Environmental Management & Construction Plan - Notice of Minor Change

Project:	Alle-Catt - NY Wind Project	Case #:	001}	
Location	Allegany, Cattaraugus, and Wyoming County, NY	Change #:	14	
Applicable Certificate	Article 10			
Reference Drawing/Location of Change:	C-205, C-257, C-259A			
Features Changed: Invenergy is proposing to shift tower coordinates at the following locations: T-14- 12ft shift east T-57- 6ft shift southwest T-88- 34ft shift west-southwest				
Change Impacts/Benefits	Yes	No	N/A	Description/Notes
Additional Ground Disturbance		✓		
Expansion of LOD's		✓		
Additional Clearing		✓		
Other Impact		✓		
Mitigate/Eliminate impact to other area(s)		✓		
Mitigate/Eliminate impact to wetland(s)	✓			T-88 shift will be to reduce/eliminate wetland impacts.
Mitigate/Eliminate disturbance in other area(s)		✓		
Other Benefit		✓		
Landowner approval (if necessary)			✓	
Rationale for Change: T-14- 12ft shift east; to be further within the FAA "Determination of No Hazard" latitude/longitude bounds T-57- 6ft shift southwest, to improve grading T-88- 34ft shift west-southwest, to reduce wetland impact

DRAWING NO.
C-205

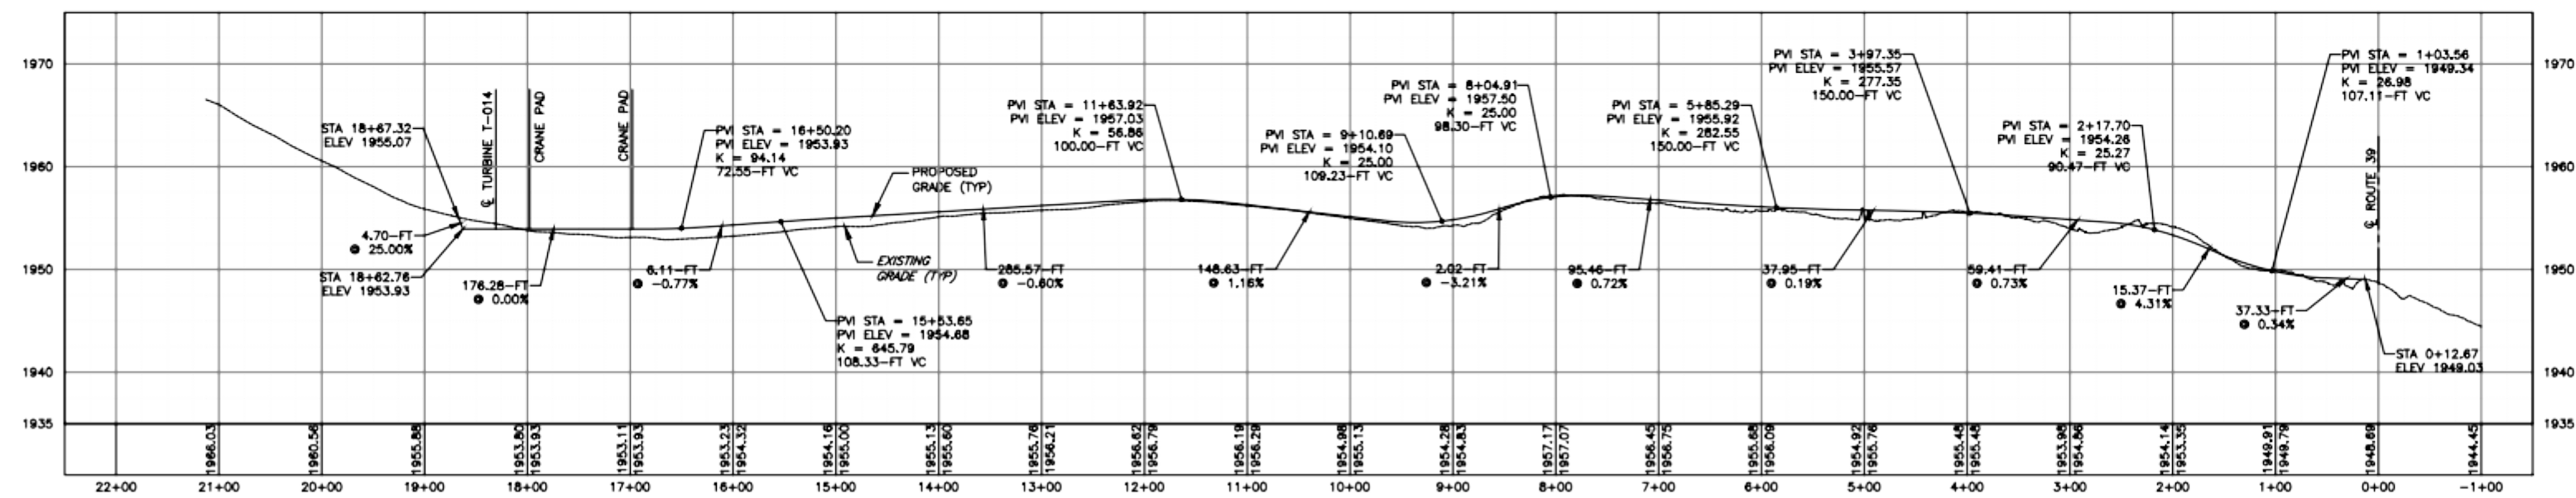
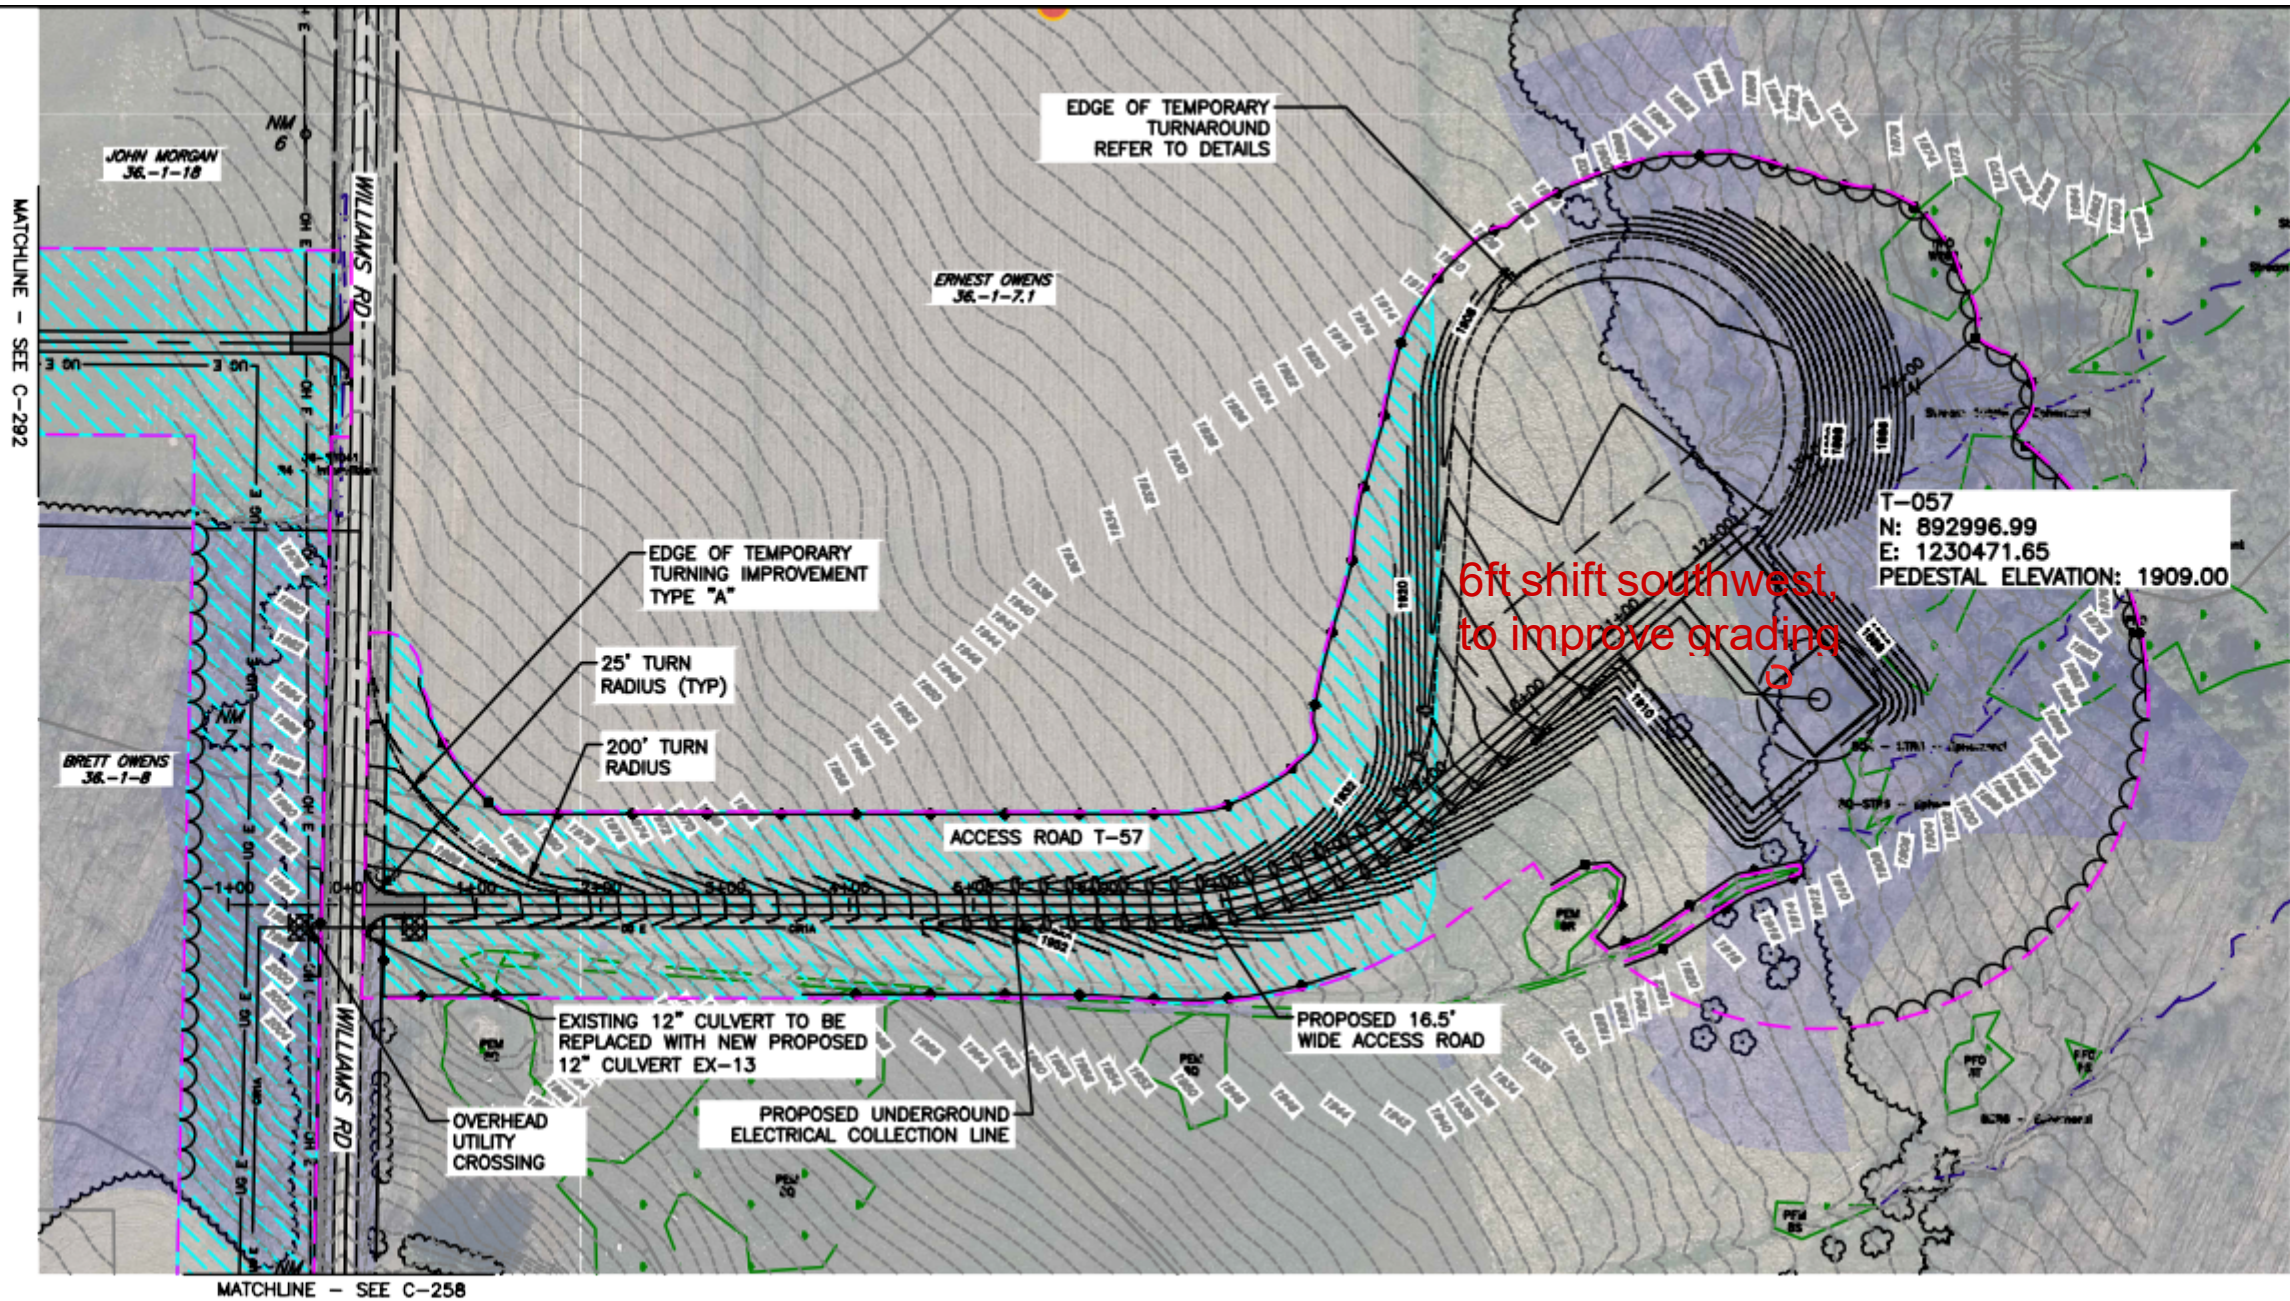
Wind Turbines						
WTG Number	Approximate Distance Change	Reason for Change	Max FAA Approved Tip Height (feet AMSL)	Tip Height (feet AMSL)	Difference in Elevation (feet)	Change in Impacts
14	12 foot shift east	Shifting to be further within the FAA "Determination or No Hazard" boundary	2,556.0	2,546.0	0.0	No changes to temporary or permanent stream impacts, no temporary or permanent change in agricultural impacts that's not anticipated to impede farming operations.
57	6 foot shift southwest	Improve grading	2,508.0	2,500.0	0.0	No changes to temporary or permanent stream impacts, no temporary or permanent change in agricultural impacts that's not anticipated to impede farming operations.
88	34 foot shift west/southwest	Reduce wetland impact	2,660.0	2,650.0	0.0	Reduction in up to 0.2 acres of temporary wetland impact and 0.008 acres of permanent wetland impact, no temporary or permanent change in agricultural impacts.
